ONSITE SEWAGE DISPOSAL SYSTEM

PROPERTY ADDRESS: 14290 Triadelphia Road

From: Williams, Jeffrey
Sent: Monday, February 02, 2015 3:16 PM
To: 'Stephanie Tuite'
Subject: RE: Homewood Interiors BAT (14290 Triadelphia Rd)

SDP-15-010

CONDITIONAL USE AND VARIANCE PLAN
14290 TRADELPHIA ROAD
TAX MAP #61 PARCEL #35 GSD 16
FOURTH ELECTION DISTRICT HOWARD COUNTY, MARYLAND
ZONING RC-300
SCALE 1"=50'
DATED FEBRUARY 17, 2014
SHEET 1 OF 1

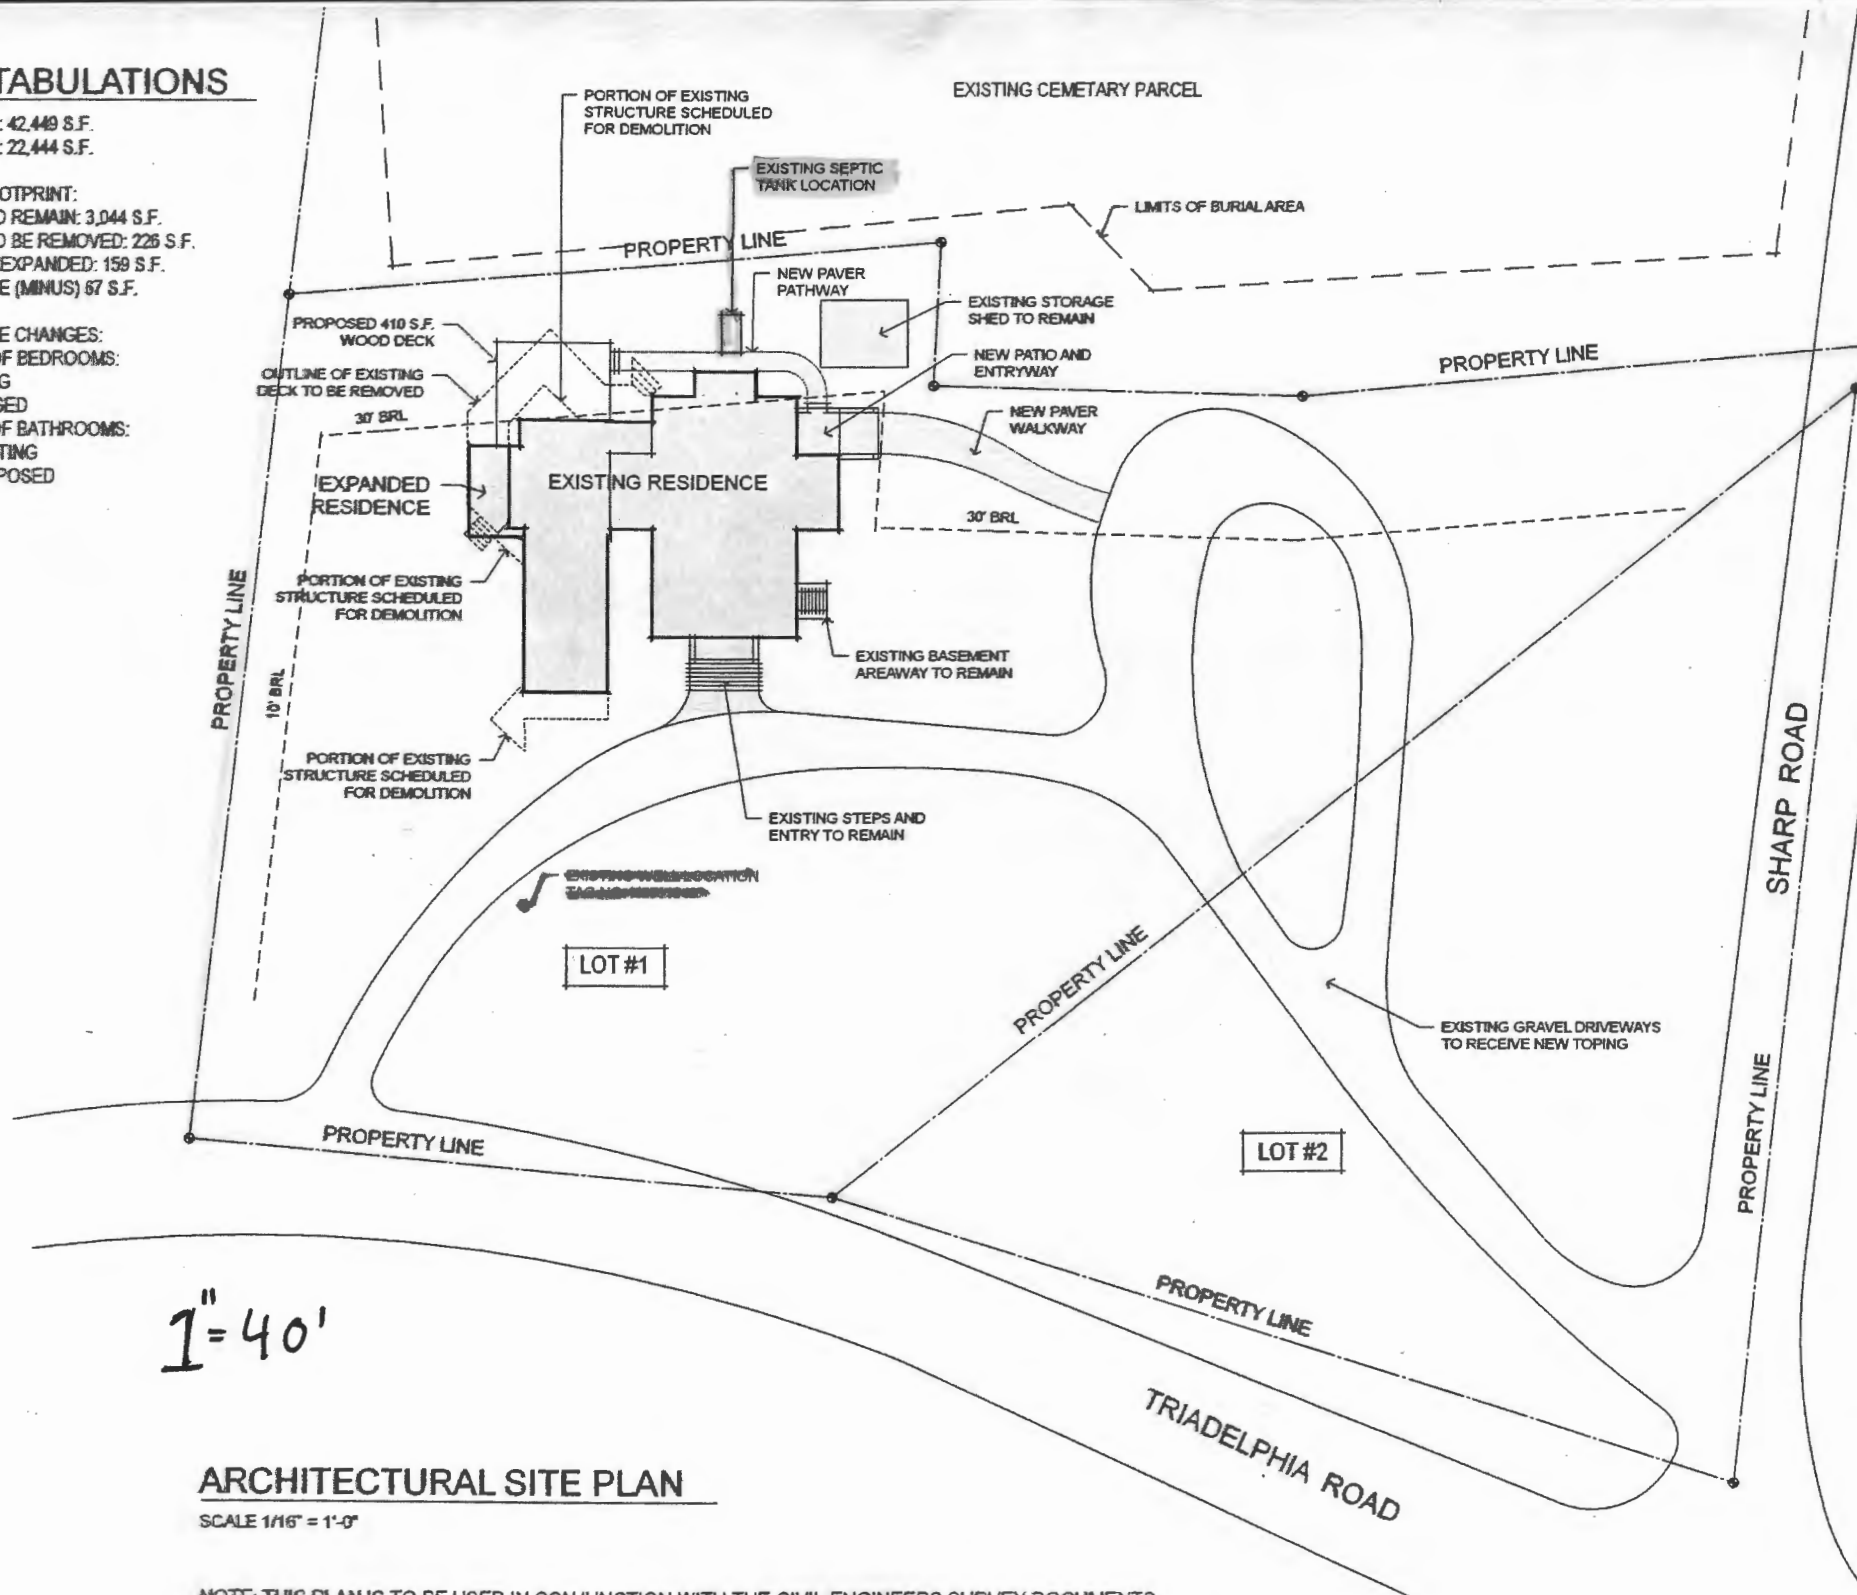
In response to an email dated May 28, 2014 from Jeff Williams with the Howard County Health Department To Mr. Anthony Fertitta with Fisher, Collins And Carter, Inc., we are requesting a variance for the proposed septic easement on 14290 Triadelphia Road located 200' above gradient from the neighboring well on 4050 Hobbs Hill Road.
